FINAL ENVIRONMENTAL IMPACT REPORT

BELVEDERE-TIBURON LIBRARY EXPANSION PROJECT

SCH# 2009052003

August 2011

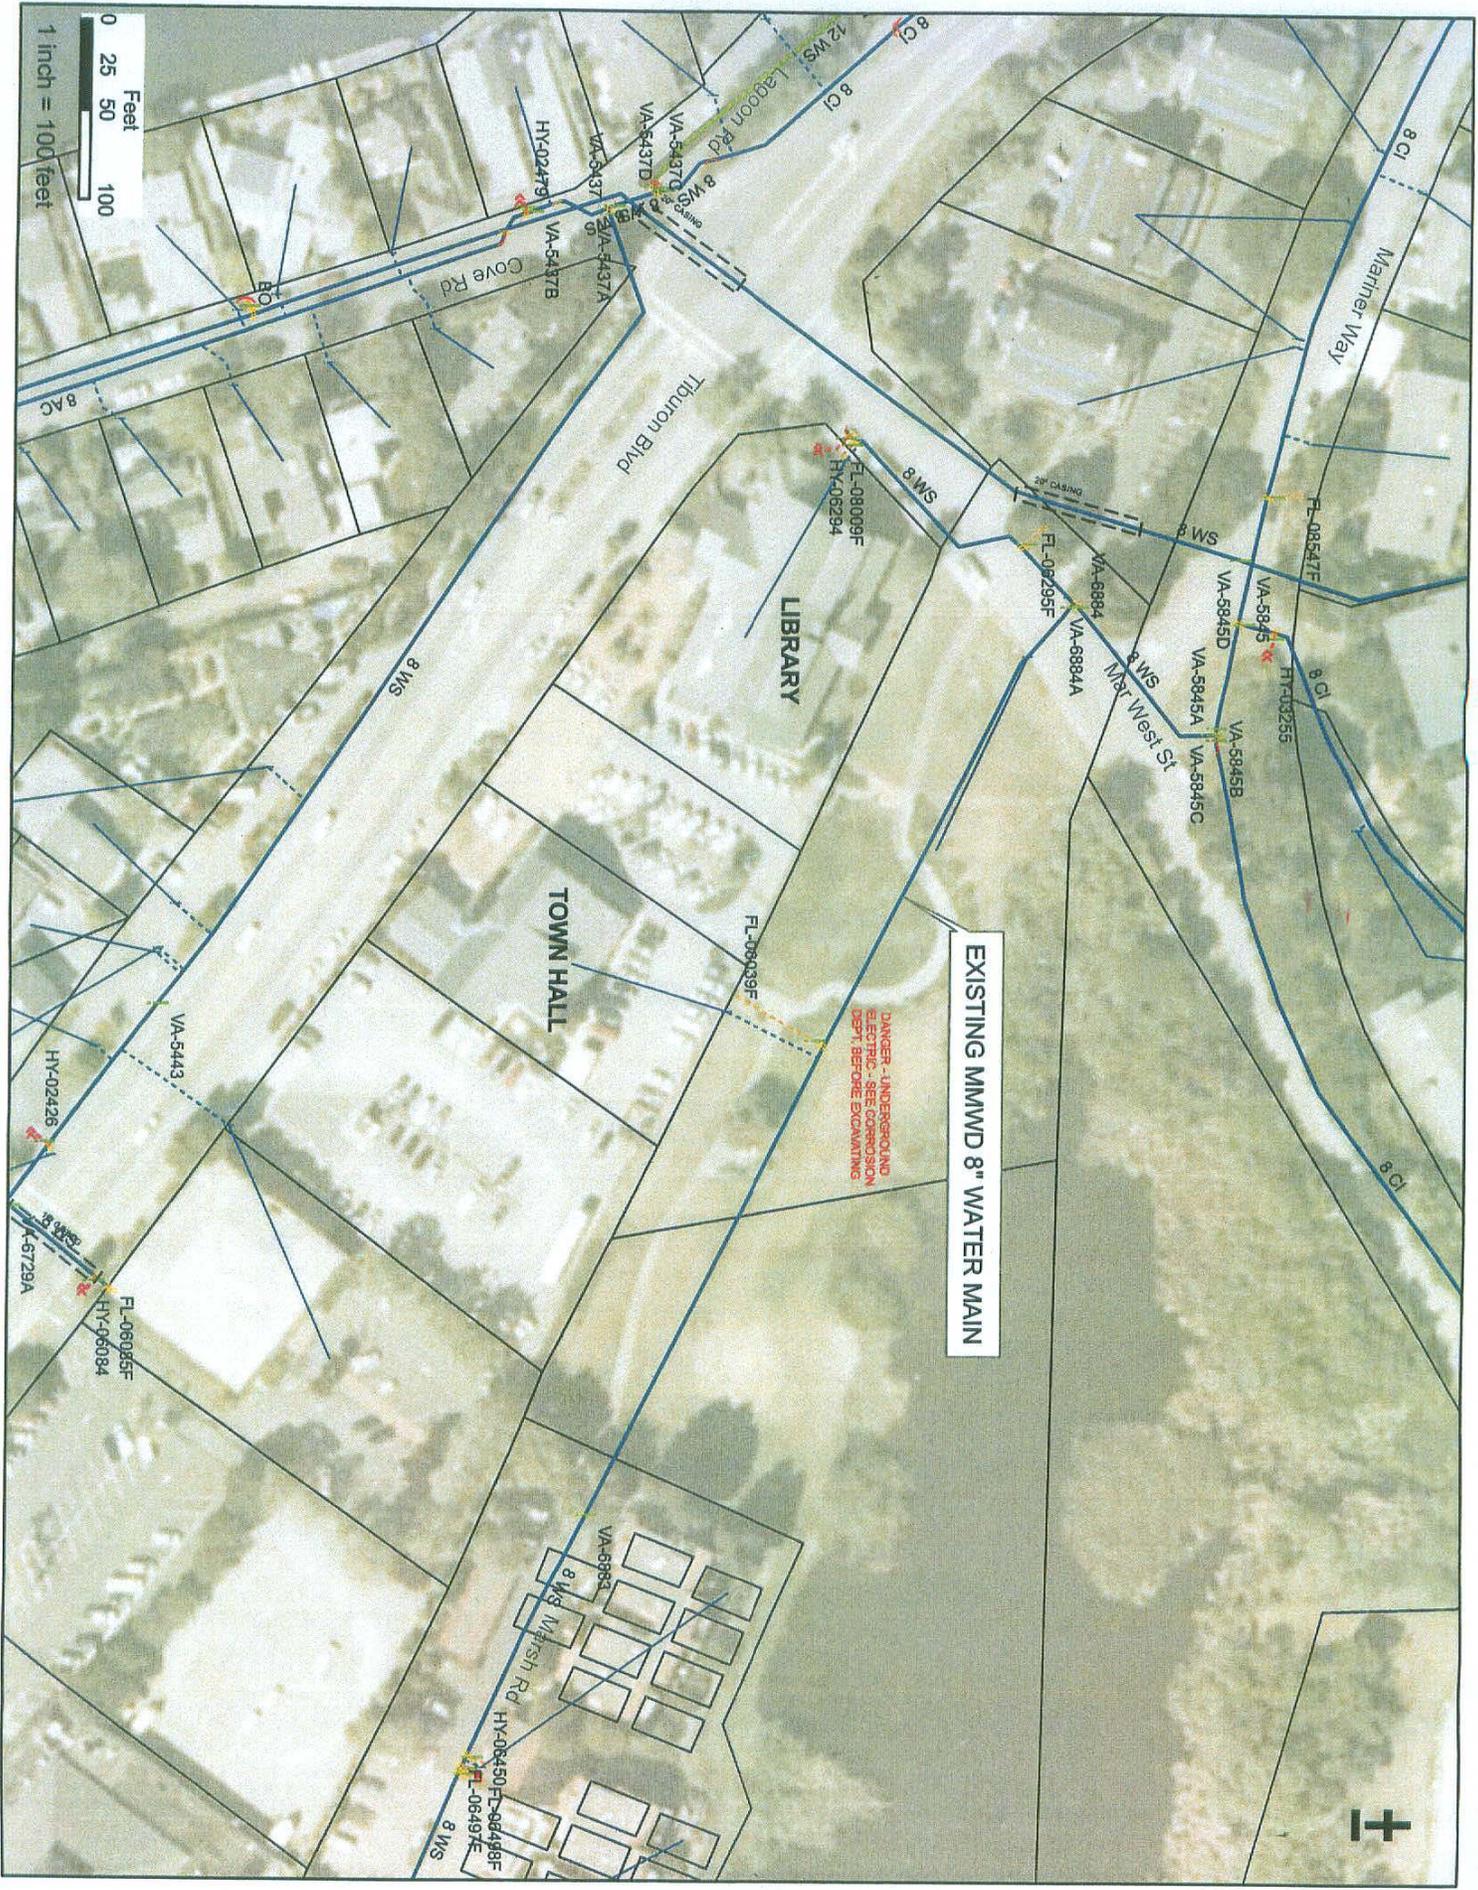
The DEIR for the subject project was circulated for staff review here at MMWD. Based on the site plans it appears that the new parking area may conflict with the District's 8-inch water main. Typically our water mains are installed with about 30-inches of cover. The cross section indicates some lowering of the existing grade and the pervious pavement typically involves the installation of a foot or two drain rock below the surface. There is a potential that this activity will result in damage to the water main and/or not provide sufficient cover to protect the main from future damage. I have attached a figure which shows the approximate location of the District's water facilities. 4-1

- 4-1. This letter raises a concern that was raised in Comment Letter 3 above. See the response to that letter.

Photograph 1 - Existing View with No Leaves on Trees

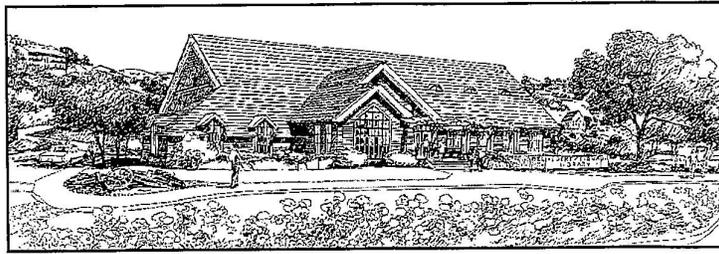
viewing places including Tiburon Boulevard” (RDEIR, page IV.B-10). As is shown on Figure VI-4 of the Revised DEIR, the project as proposed almost entirely blocks views of the grassy portion of the ridge from the selected vantage point. Alternative D allows views of a portion of that grassy area. On this basis, the Revised DEIR concludes that this impact is reduced sufficiently to make the impact less-than-significant. The Town has the authority to conclude otherwise. In that case, this visual impact would be one of the significant and unavoidable impacts the Town would have to accept (in a Statement of Overriding Considerations) if it chooses to approve the project or Alternative D.
